TECH-HINT

Gluing unit upgrade

MACHINE TYPE: 121 – 121A REFERENCE CODE: AF.063

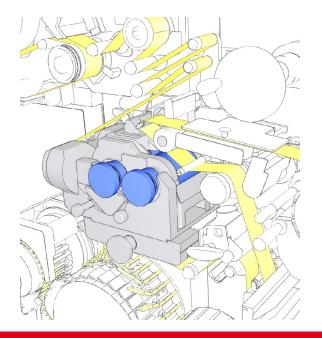
The kit replaces the tipping paper gluer unit with a new version without the glue pot.

The previous version features two overlapped rollers with the lower one partially dipped in the glue.

The new solution features instead the glue depositing between the two rollers by means of a nozzle, thus eliminating the need to have a glue pot. In addition, the problems of glue heating and air particles inclusion in the glue (due to the roller movement in the pot) are avoided.

With the nozzle application, the glue quantity is accurately controlled and the supply is stopped in case of machine downtime, avoiding waste and glue residuals.

The upgrade features an internal cooling system of the rollers, that permit to keep constant the glue characteristics, and an increase of the roller diameter thus reducing their speed.

The group is completely extractable for maximum accessibility in case of cleaning operations.
